## **PAM-HSL AIR ARCHITECTURAL DESIGN COMPETITION**

# **NOTES TO QUERIES & ANSWERS**

**QUERIES & ANSWERS**

Query 5 - to provide width of drain/river reserve (DID request) if any

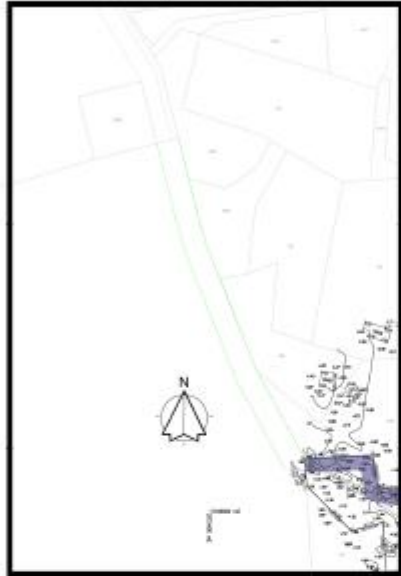
Answer	Not relevant to this competition
Q116	To provide the existing width of the drain/river reserve (request from DID) if any
Answer	Refer Q10

Query 3 - to provide drain layout and invert level on lot 20600 & 20604

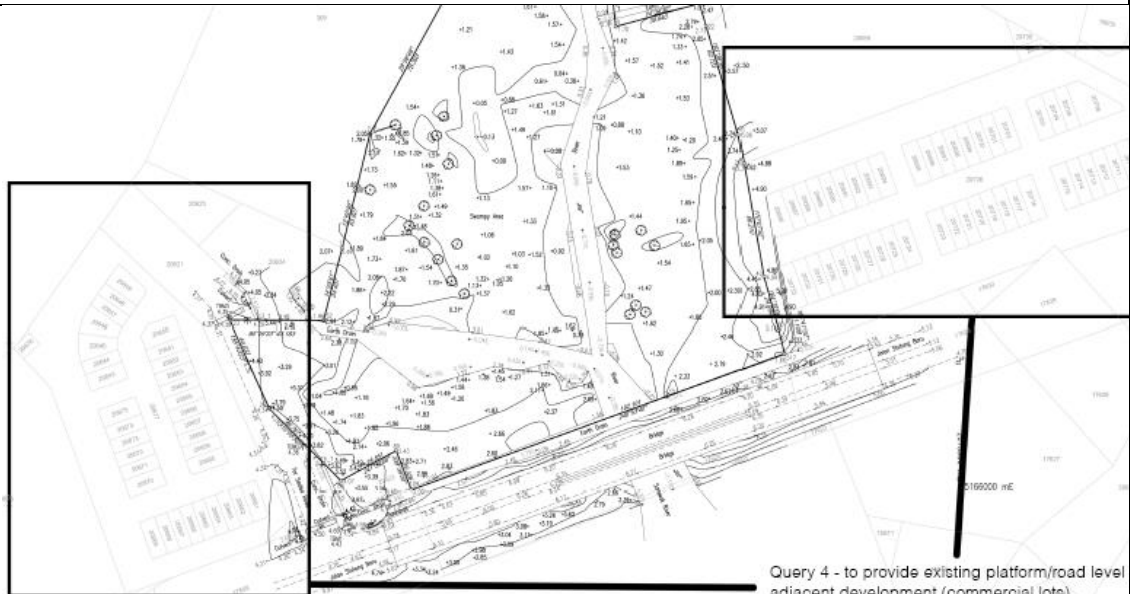
Answer	No Information available
Q115	To provide drain layout and drain invert level on lots 20600 and 20604 (missing link between KPJ and our proposed site)

Query 4 - to provide existing platform/road level adjacent development (commercial lots)
